DEVIATION REQUEST (Attach diagrams, figures, and other documentation to clarify request)

A deviation from the standards of or in Section **2.3 Roadway Design** of the Engineering Criteria Manual (ECM) is requested.

Section 2.3 Roadway Design, Detail SD_2-11

SD_2-11 Typical Rural Local Cross Section

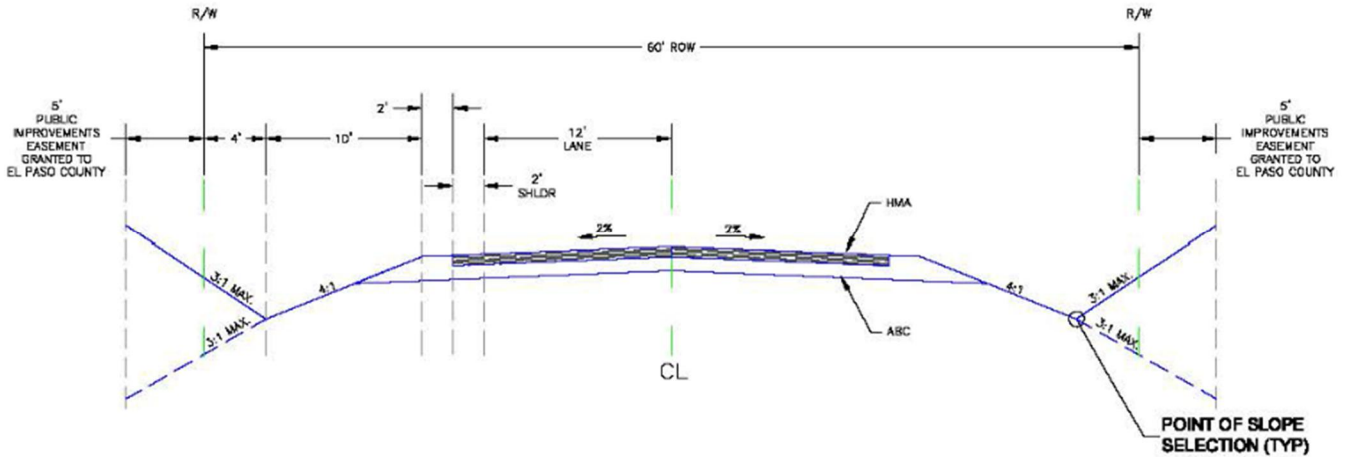
A request to modify the typical rural local cross section allows for an 8-foot regional trail to be constructed along the south side of Apex Ranch Road. The EPC Parks department has requested a proposed 25' easement outside of the right of way will reserve adequate space for the trail to be built at a future date along the Apex Ranch Road alignment. This will connect Homestead Park (El Paso County Park) to Tract E and D within the Apex Ranch Subdivision, which are dedicated for public trail use.

A modified typical section illustration is provided below:

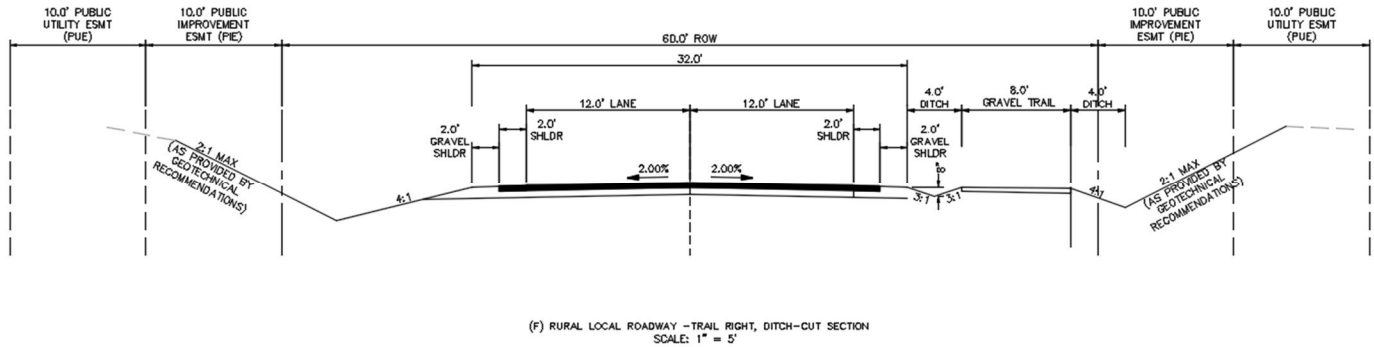
The proposed modified cross section intends to closely follow the Rural Local Cross Sections SD_2-11 with the following modifications:

1. 2:1 backslopes (as provided by geotechnical engineering recommendations), to accommodate large cut sections
2. 8-foot trail on the right side of the alignment
3. A 4-foot, 8 inch deep, roadside ditch between the trail and gravel shoulder for drainage runoff from the right lane of the proposed roadway
4. A 1-foot-deep roadside ditch between the trail and the 2:1 slope
